William States Lee III Nuclear Station

COL Application

Technical Specifications

PLANT SPECIFIC TECHNICAL SPECIFICATIONS (PSTS)

Figure 4.1-1

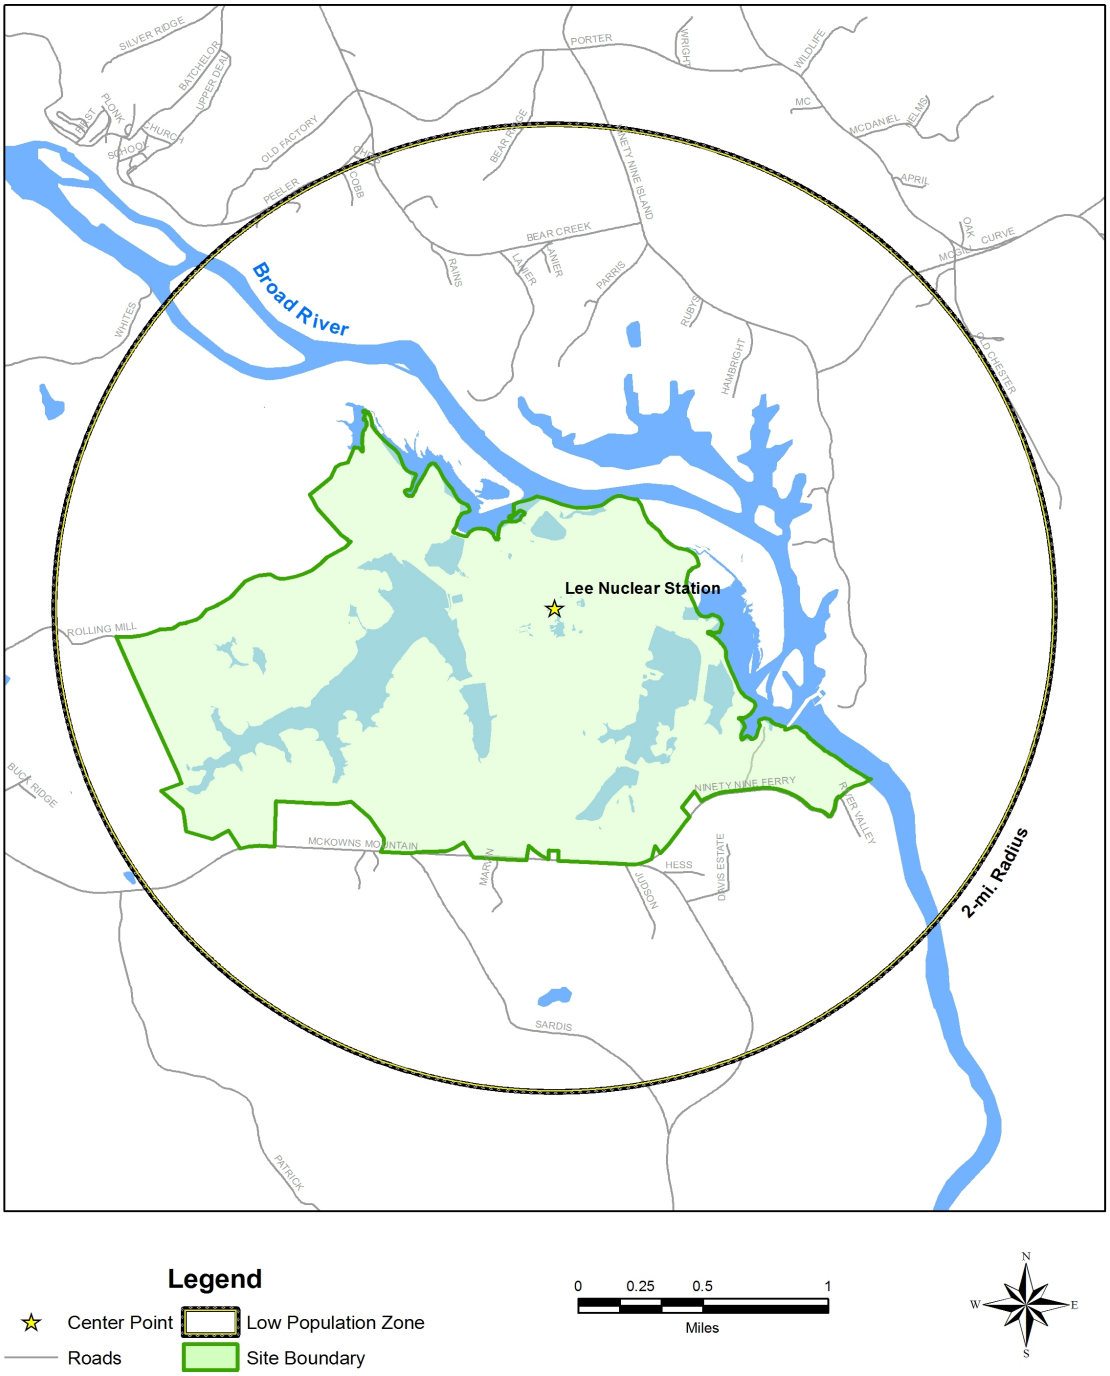
GTS 4.1.1

The bracketed information in the GTS reads:
[This information will be provided by the combined license applicant.]

Replace the bracketed information in the GTS with the following:
The Site Boundary is shown in Figure 4.1-1. The Exclusion Area Boundary is shown in Figure 4.1-2.

Replace the bracketed information in the GTS with the following:
The LPZ is defined by the 2 mile radius from the site center point as shown in Figure 4.1-1.
